Rezoning Transportation Analysis

Petition Number: #2022-125

Revision Log:

Date	Description
12-29-22	First Review (TM)
01-27-23	Second Review (DR)
02-23-23	Third Review (TM)
03-30-23	Fourth Review (TM)

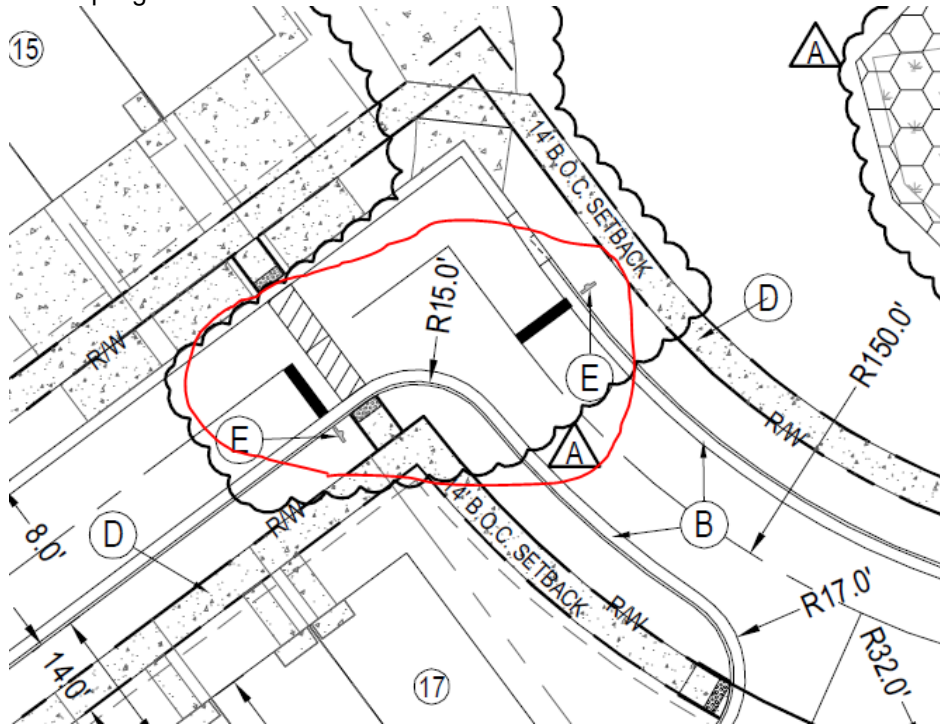
6. ~~Revise site plan and conditional note(s) to meet CDOT standards for public roadway geometry. Label each roadway as public or private.~~

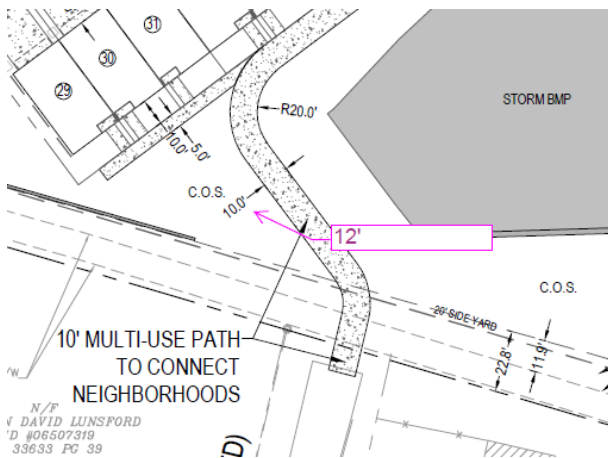
Clarifying Comment 01-27-23: CDOT will not accept current design. Revise roadway to remove 90 degree turn and satisfy CDOT standards for public roadway geometry. Remove crosswalk, stop bars, and stop signs.

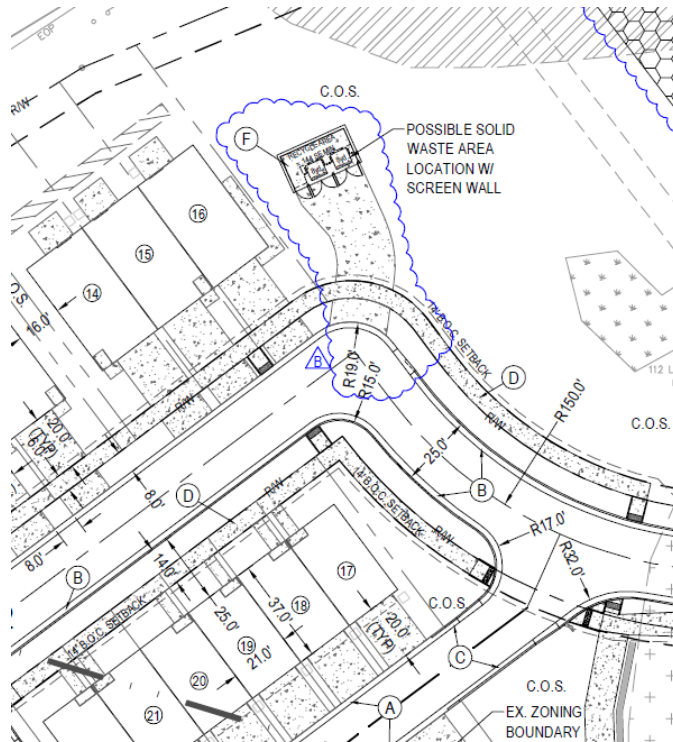
7. ~~Revise site plan and conditional notes(s) by changing the 10-foot Multi-use path to a 12-foot multi-use path.~~
